HOSHIZAKI AMERICA, INC.

SERVICE BULLETIN

SB94-0004

SUBJECT: DISCONTINUED PARTS

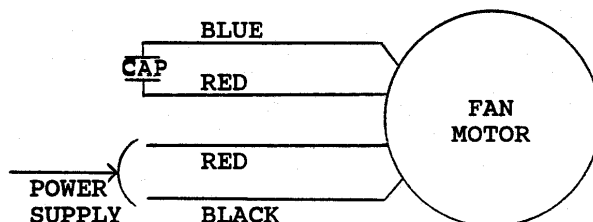
The new fan motor has 4 leads and should be wired according to the following diagram.

NOTE: The red leads are interchangeable
